**Application for Revision to Approved Plans**

Project Address: 10 Hobby Lane, Bedford, NY

Revised Rear Deck and outside kitchen & Roof Added over outside kitchen.

Revised Deck and outside Kitchen with New Roof  
Added. No Footprint Change.

POSTENSTEIN RESIDENCE  
 10 HOBBS LANE  
 BEDFORD NY 10506  
 SIDE ELEVATION

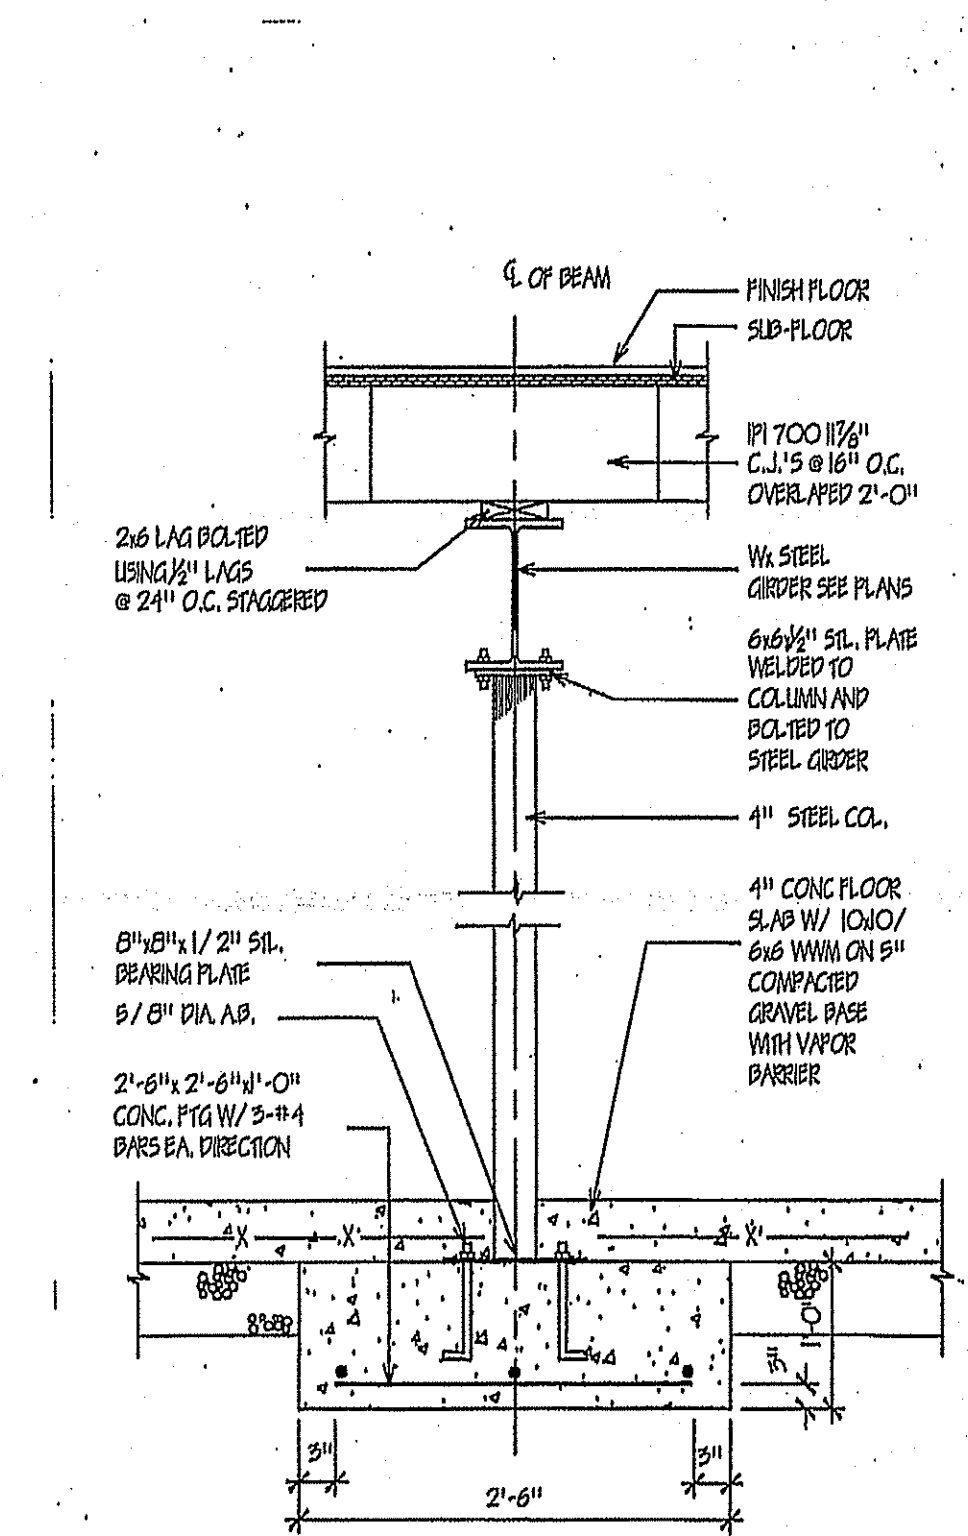
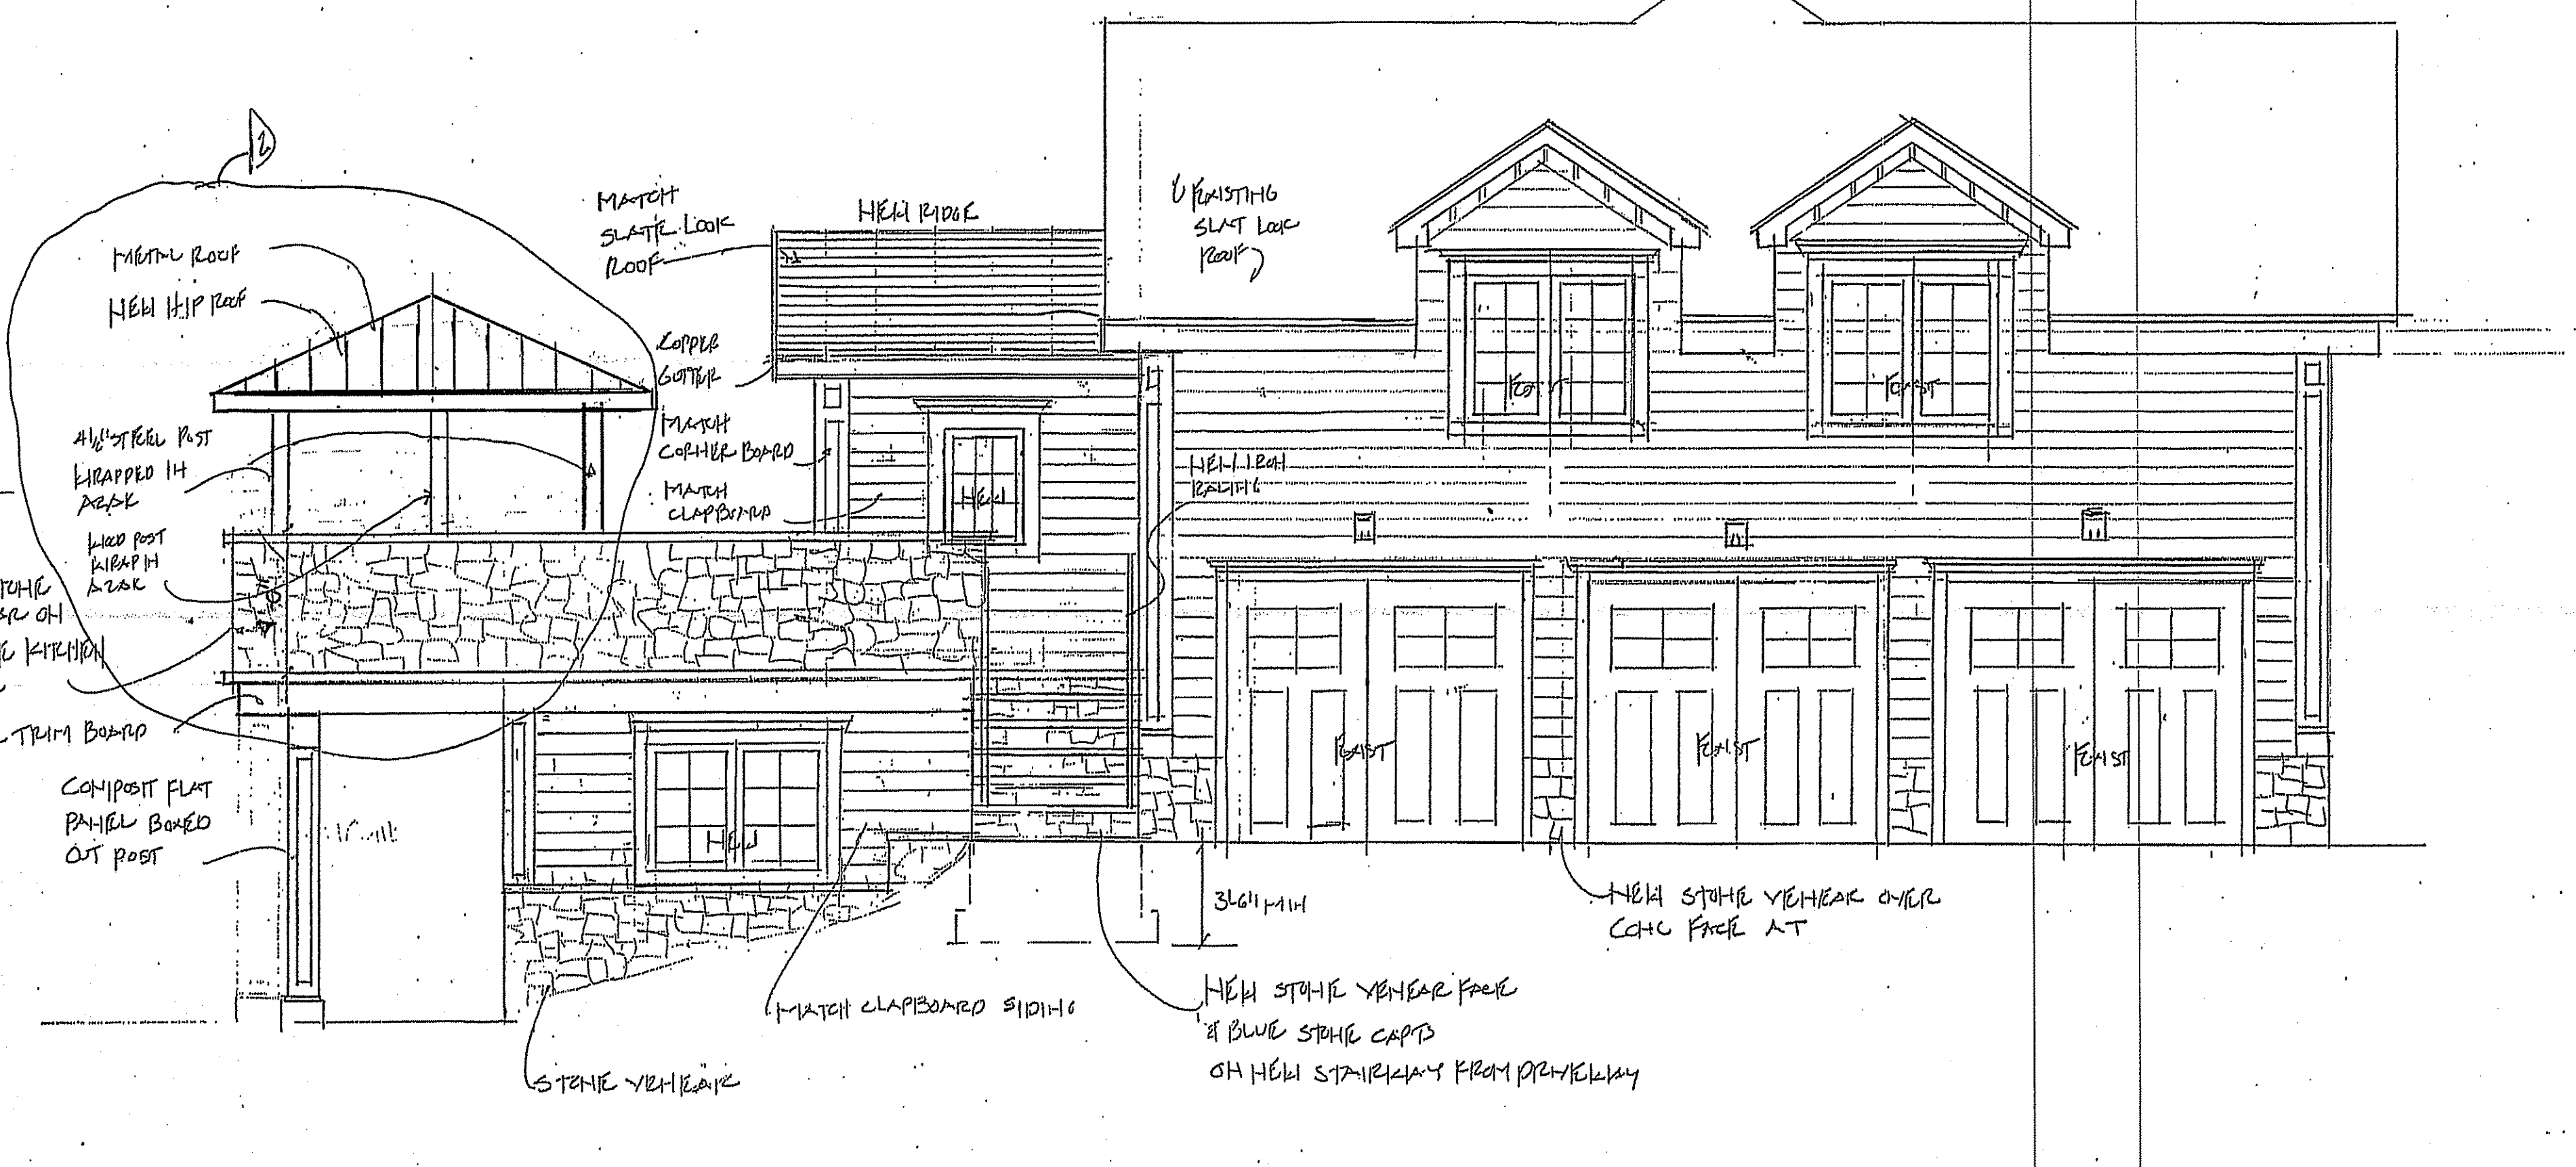
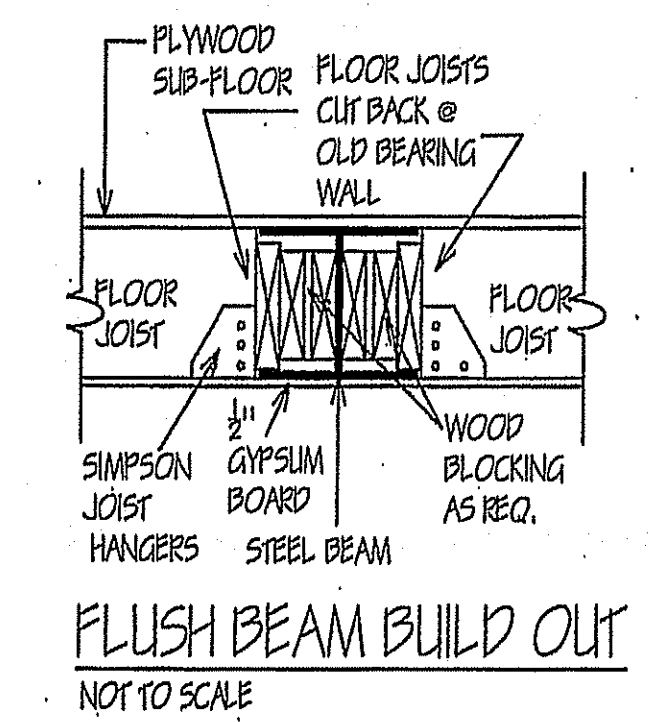
Revised Rear Deck & Roof over outdoor Kitchen 8/15/20  
 Revised PIR PLAN REVIEW 4/25/19  
 ISSUE 7/30/18

BASMENT PLAN

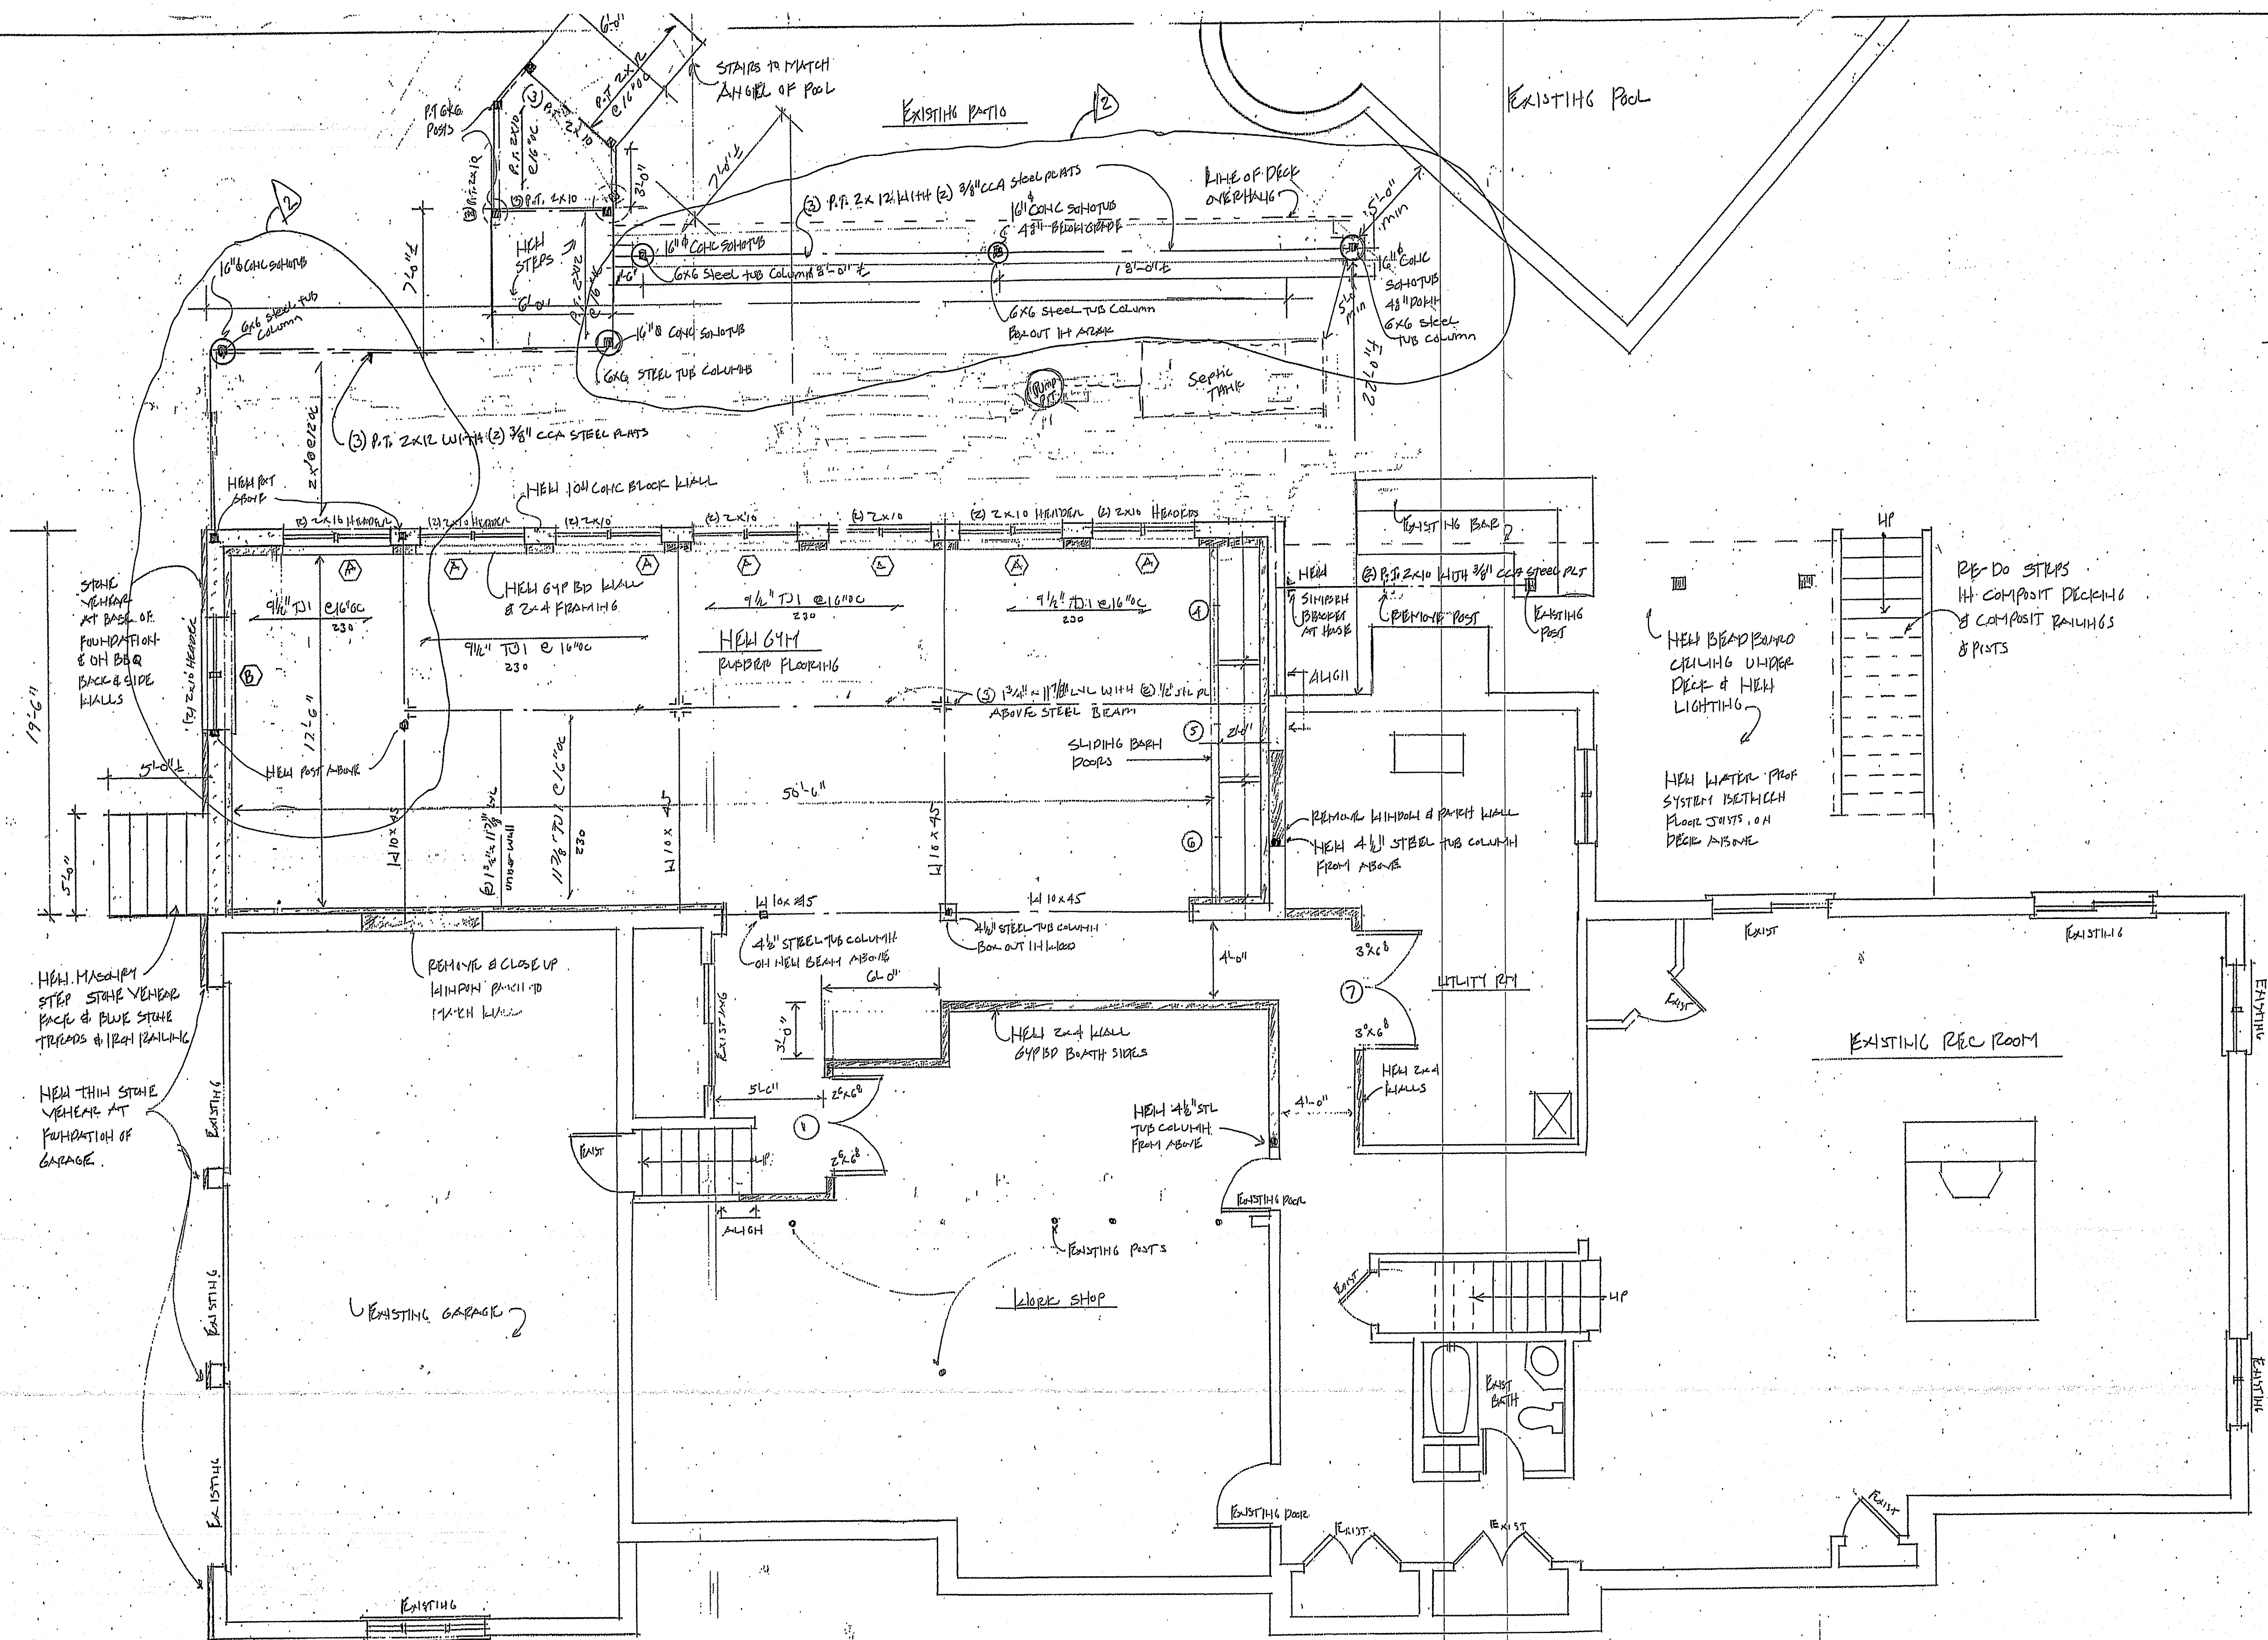
Revised Deck and Roof over outdoor Kitchen
